**TITLE: AIR CONDITIONING - AIR COOLING SYSTEM - INTRODUCE NEW
PACK PLENUM DIFFUSER**

MODIFICATION No.: 38951K12351

This page transmits Revision No.01 of Service Bulletin No.A320-21-1180

Figure A-GBAAA - Sheet 01
Location of the plenum chambers, FIN 10HM5 and 11HM5.

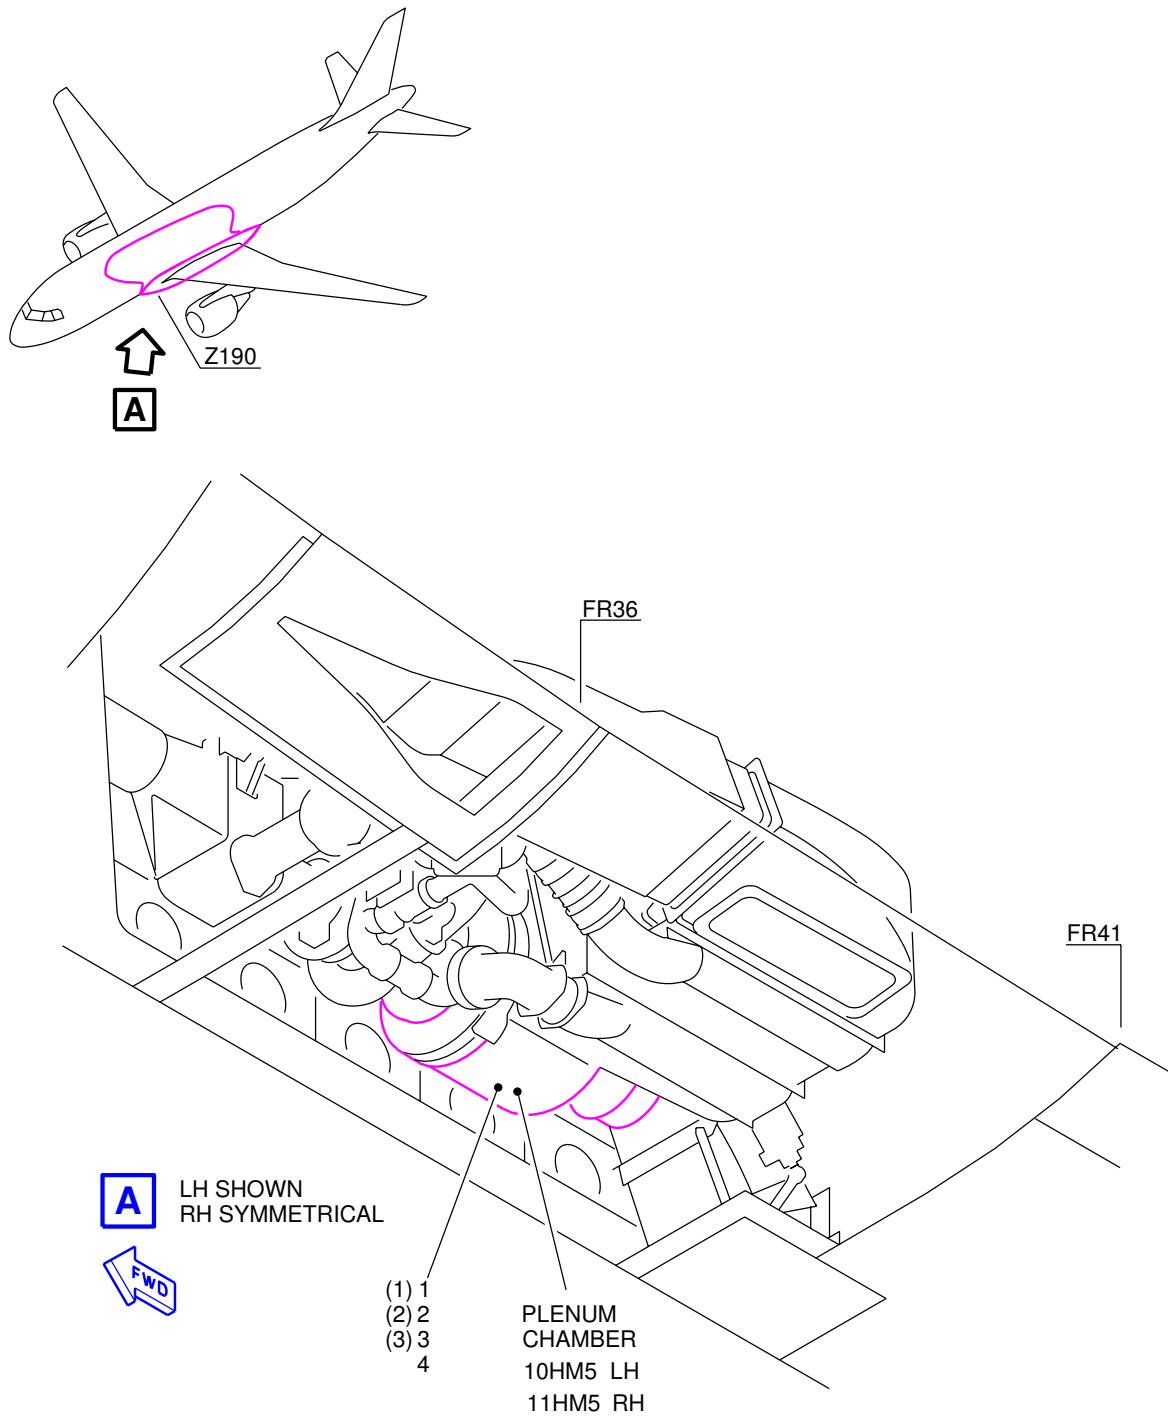
- (a) Remove the plenum chambers from the air-conditioning pack 1 and 2, AMM Task 21-52-22-000-001 and [Fig. A-GBAAA Sheet 01](#):

- (b) Send the removed plenum chambers with PN 749A0000-02 or 2056A0000-02 or 2056B0000-01 to LIEBHERR-AEROSPACE LINDENBERG GmbH for modification.

NOTE: The plenum chambers will be modified with a new diffuser made of aluminum. The PN of the plenum will be amended by the vendor after the modification.

- (c) Install the modified plenum chambers to the air-conditioning pack 1 and 2 AMM Task 21-52-22-400-001 and [Fig. A-GBAAA Sheet 01](#):
